3801 Stone Way N Seattle, WA 98103

*Supplemental Package
Design Recommendation Meeting
DPD #3014111
10.21.2013*

The developer and design team, working closely with the DPD, have made the specific revisions described and illustrated within this packet, in response to the Design Recommendations from the August 19th, 2013 DRB Meeting.

Revised East Elevation
Stone Way N

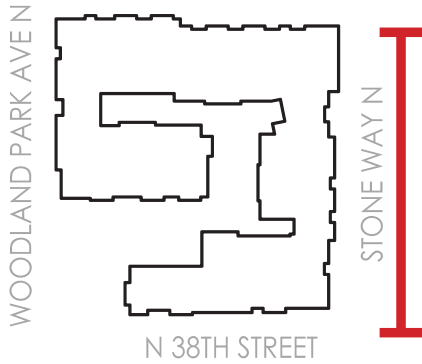
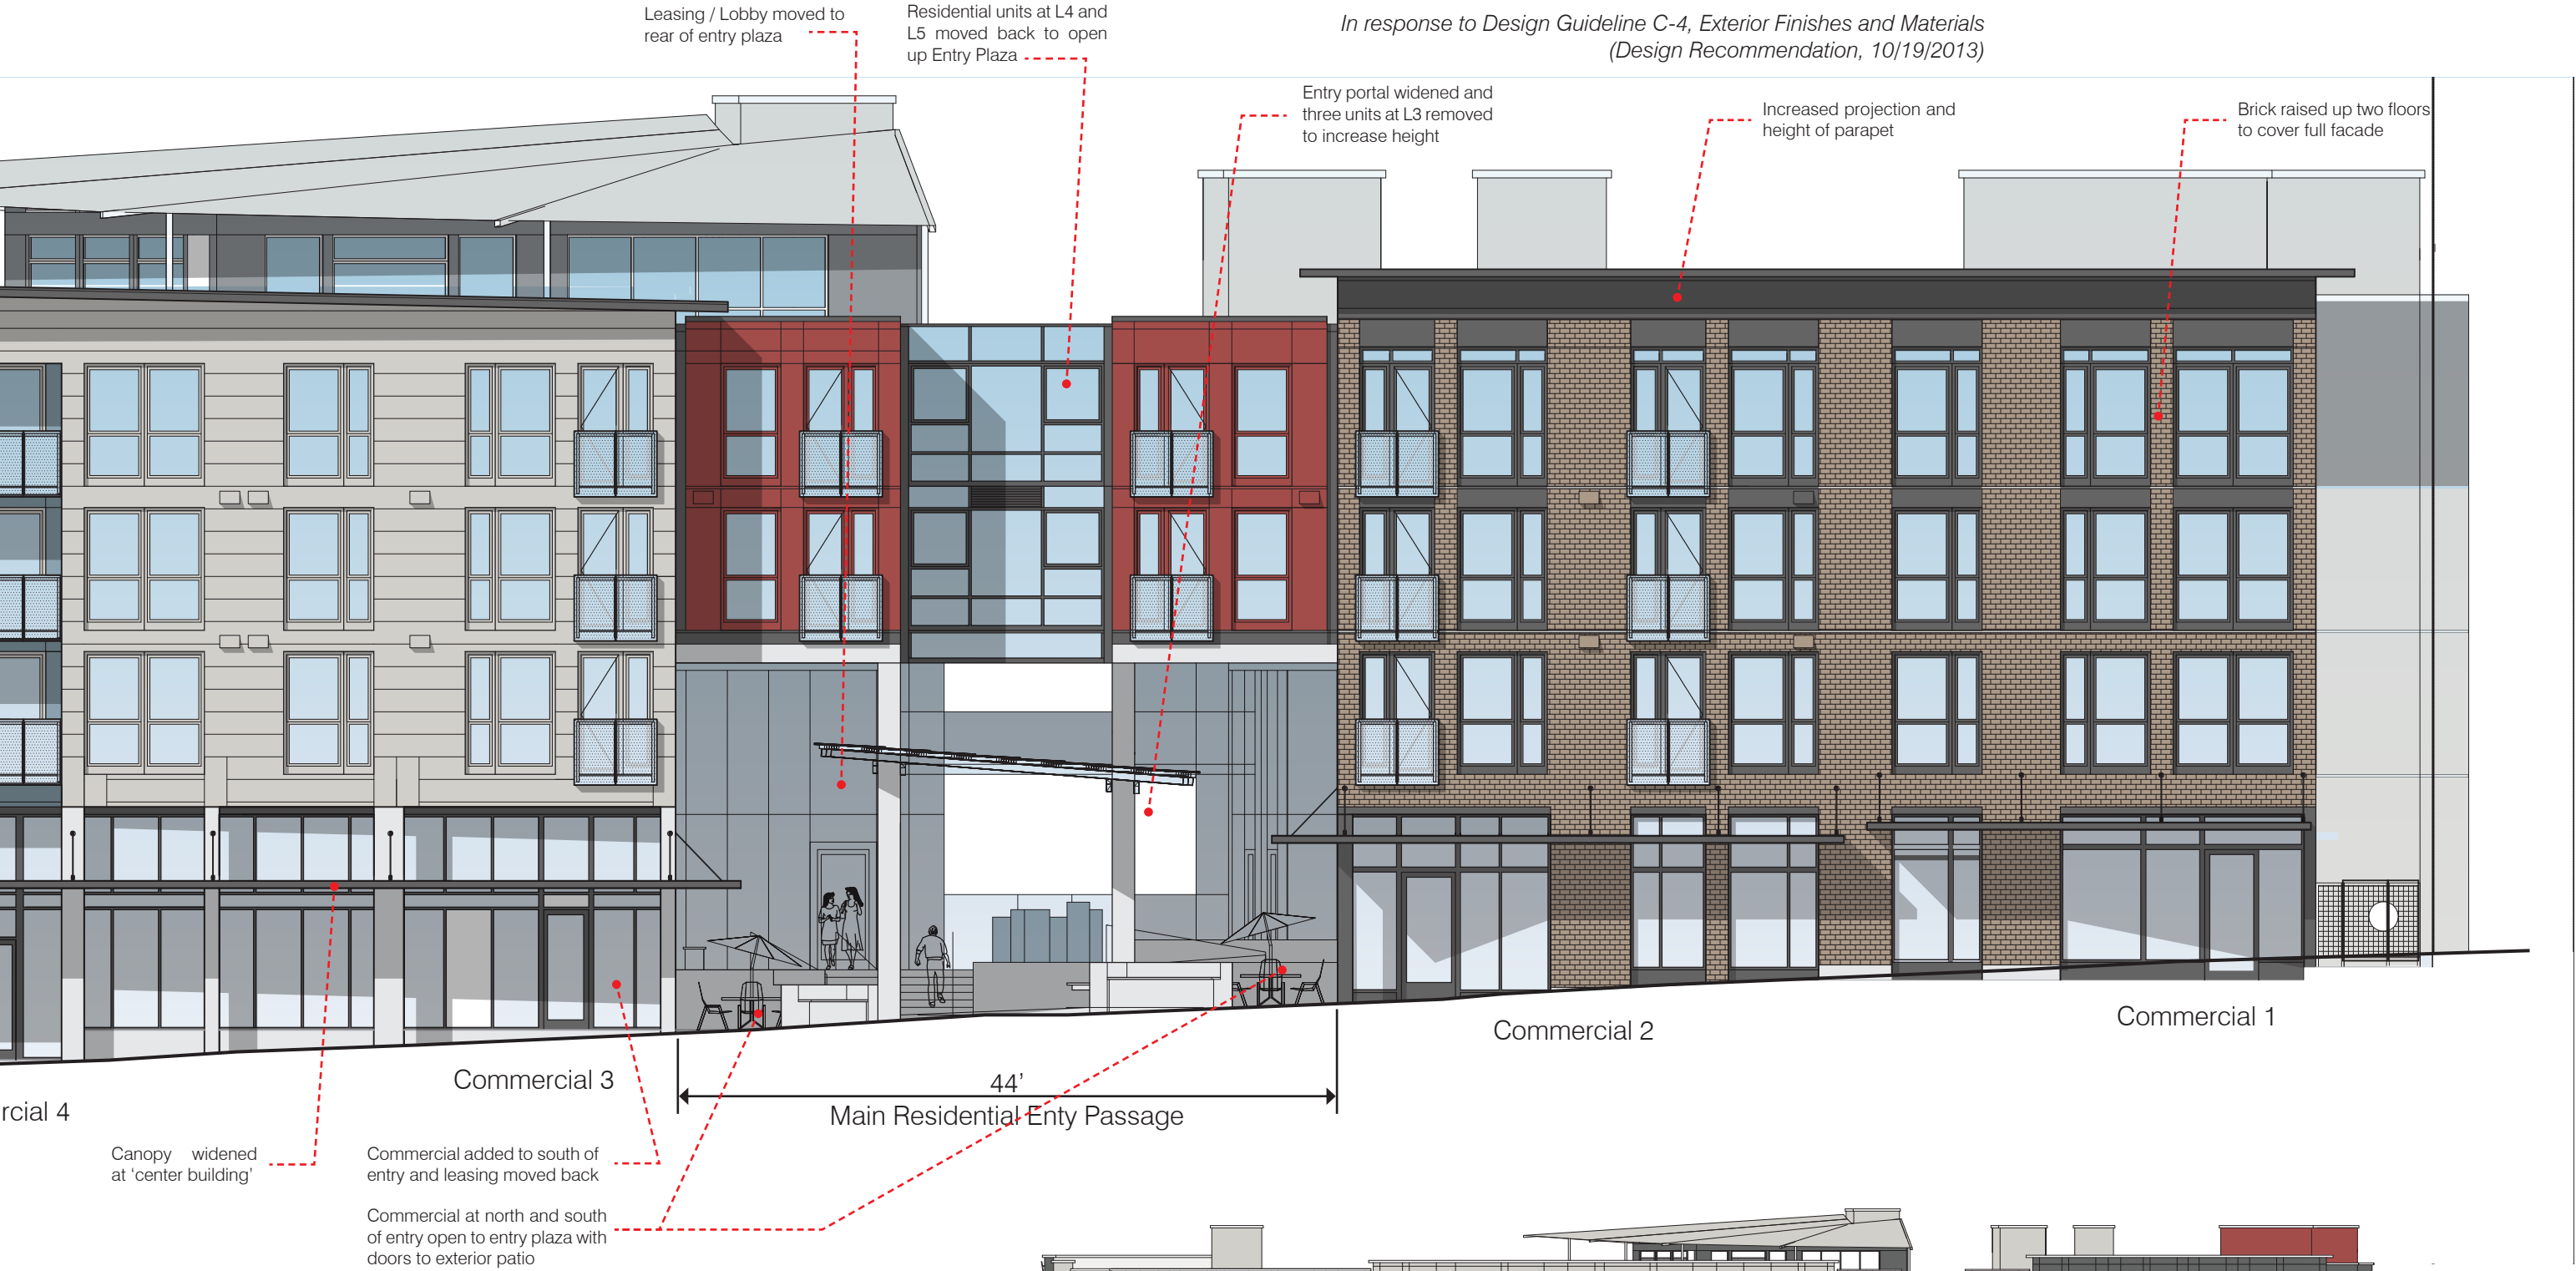
“...the vertical corner bay of windows should assume a different plane than the adjoining east and south elevations...”
In response to Design Guideline A-10, Corner Lots
(Design Recommendation, 10/19/2013)

“...The Board conveyed its interest in ensuring maximum transparency along Stone Way N and N 38th Street.”
In response to Design Guideline D-11, Commercial Transparency
(Design Recommendation, 10/19/2013)

“...Accessory uses to the residential component (bike storage, leasing office) consume much of the street frontage...In addition to the above, other elements of the three major pavilions (and an entry gasket) work against the elevation from appearing as a refined ensemble...The Board provided the following ideas to create a stronger A,B,C,A rhythm on the façade: Raise the height of

the limestone on the northern segment to create a more coherent association with the south segment; The lantern at the southeast corner ought to stand proud of the prominent vertical plane; The central “B” segment needs distinguishable or identifiable characteristics”
In response to Design Guideline C-2, Architectural Concept and Consistency
(Design Recommendation, 10/19/2013)

"The Board indicated a preference to see the brick on the northern pavilion raised another floor."

"...continuous canopies were not a necessity rather the architect should increase the depth of the canopies to extend into the rights of way when they do not interfere with the existing street trees..."

Revised Street Level Plan

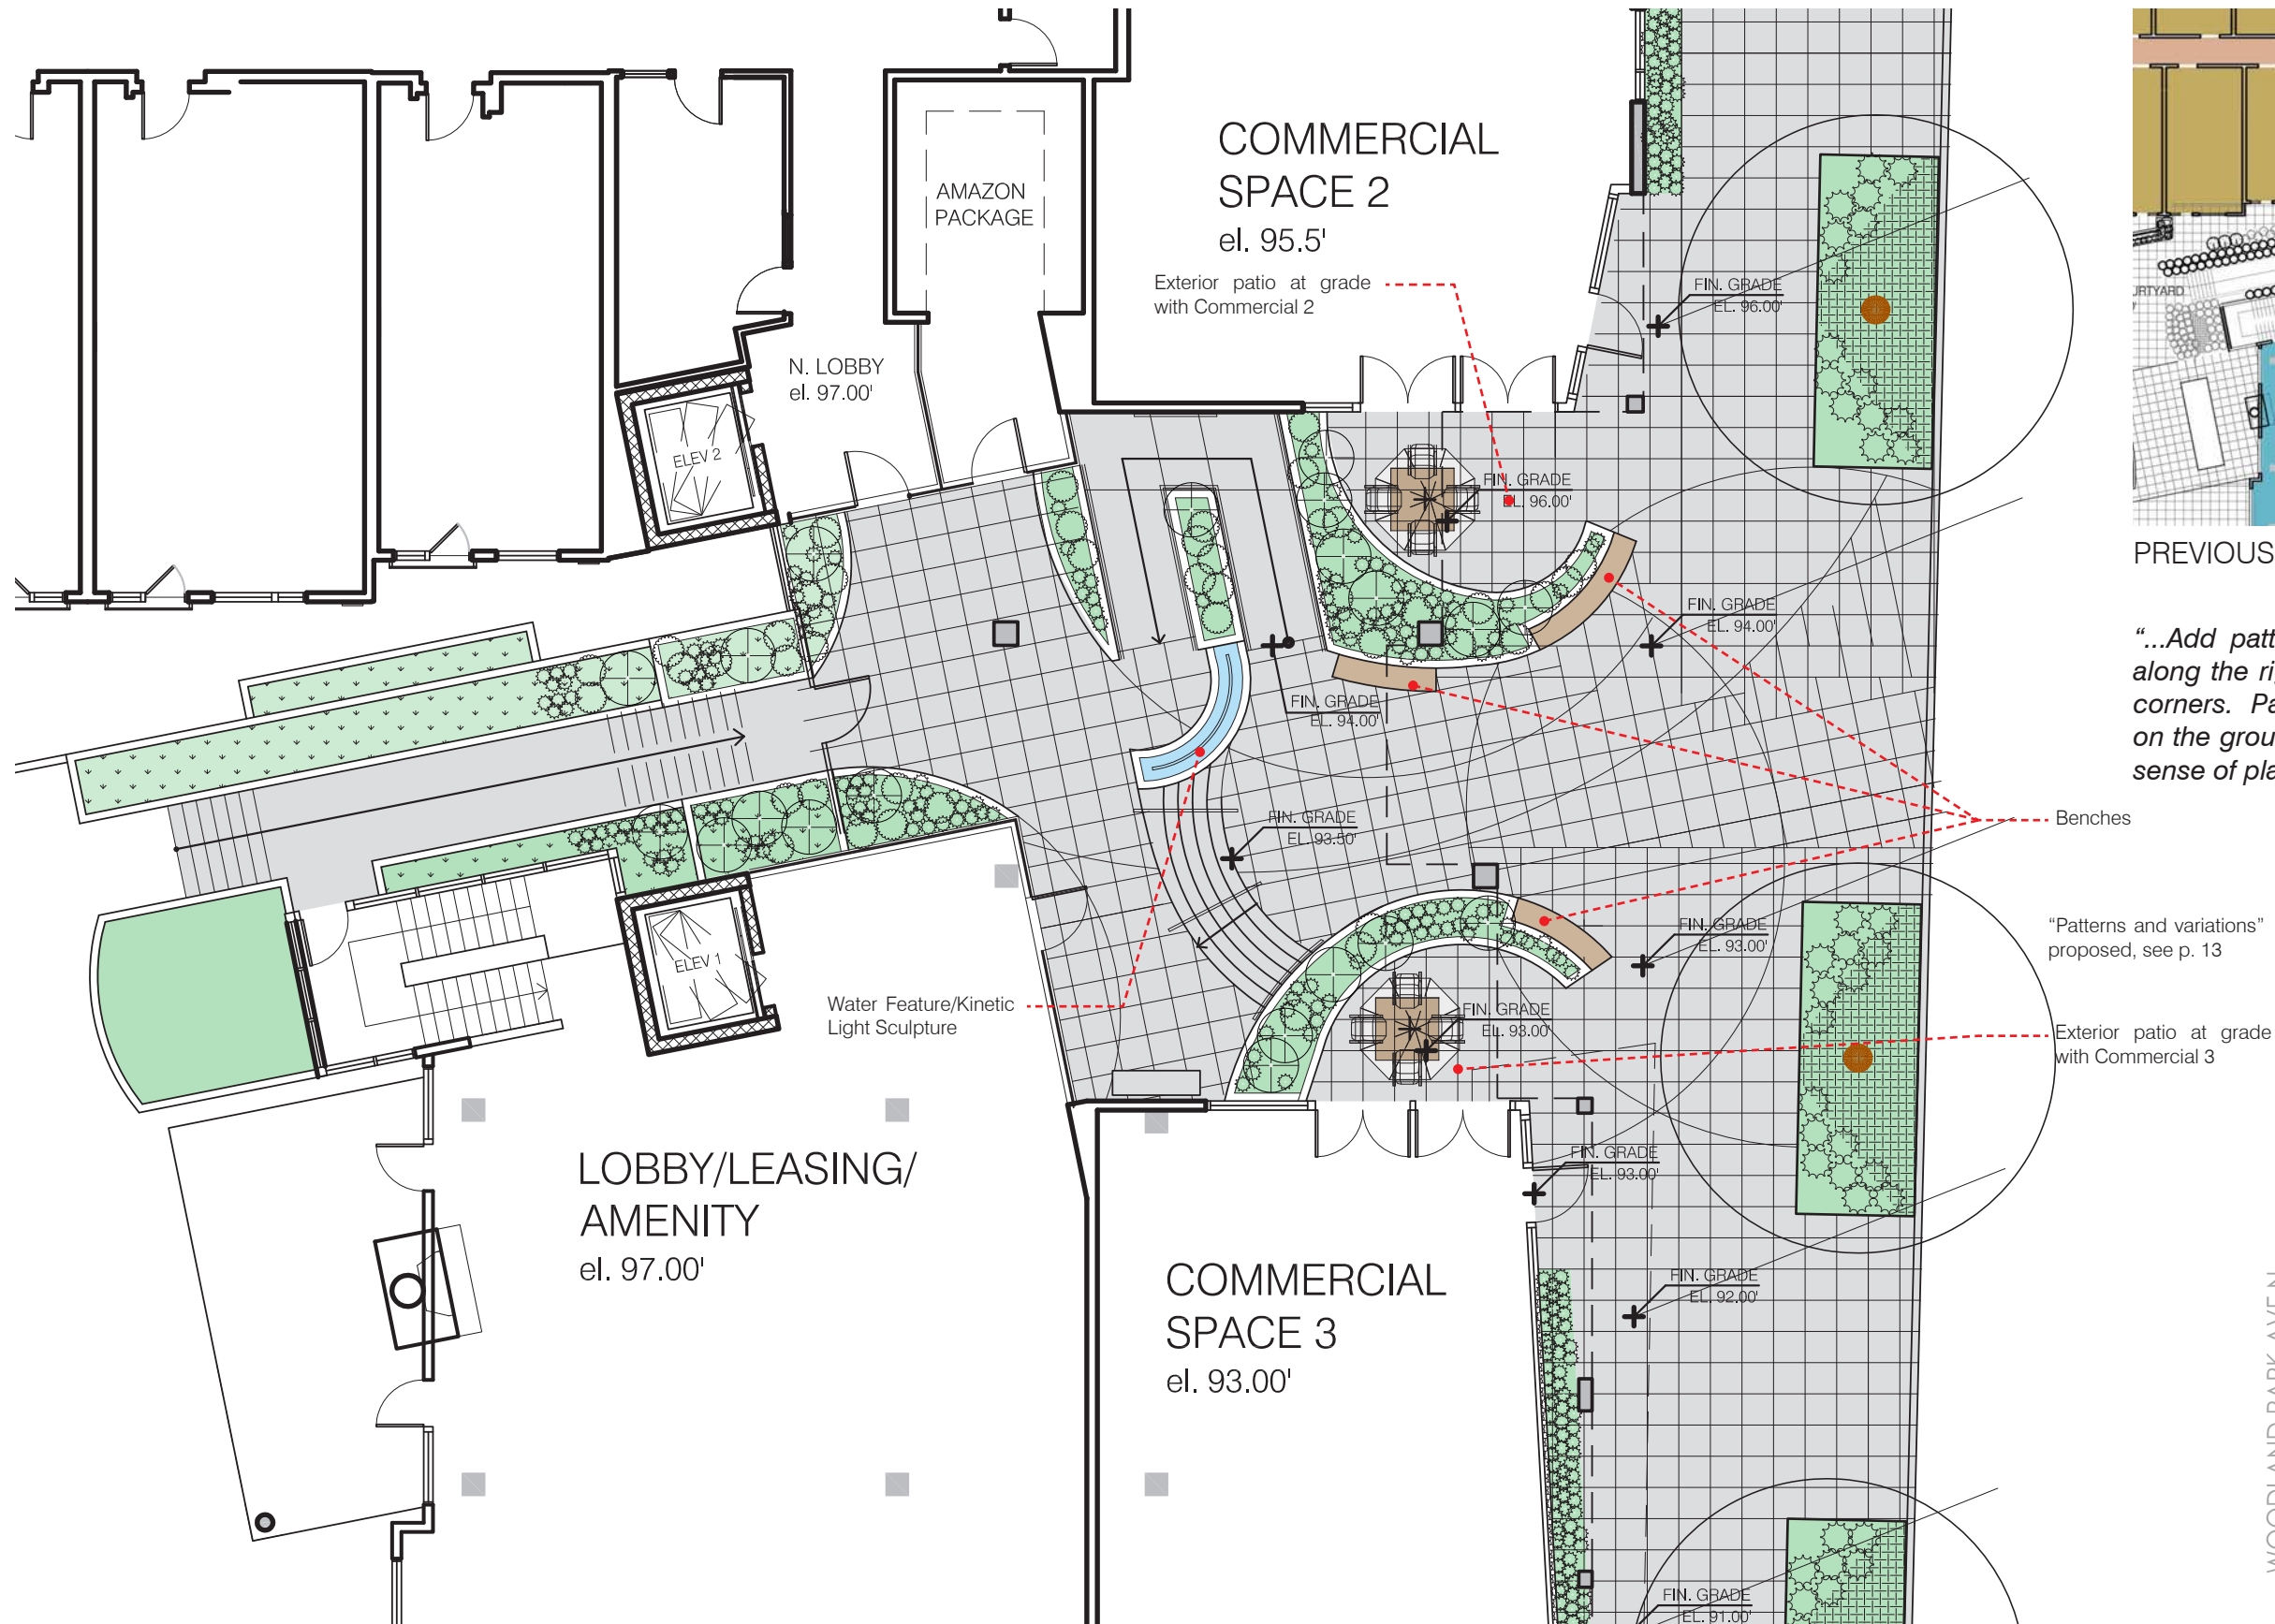
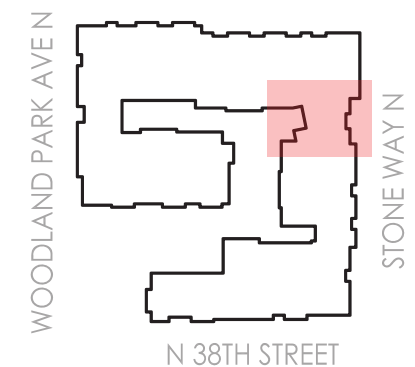
"...Add patterns and variations to the paving design along the right of way to articulate entries, plazas and corners. Patterns, street identification markers, etc. on the ground plane will help imbue the project with a sense of place."
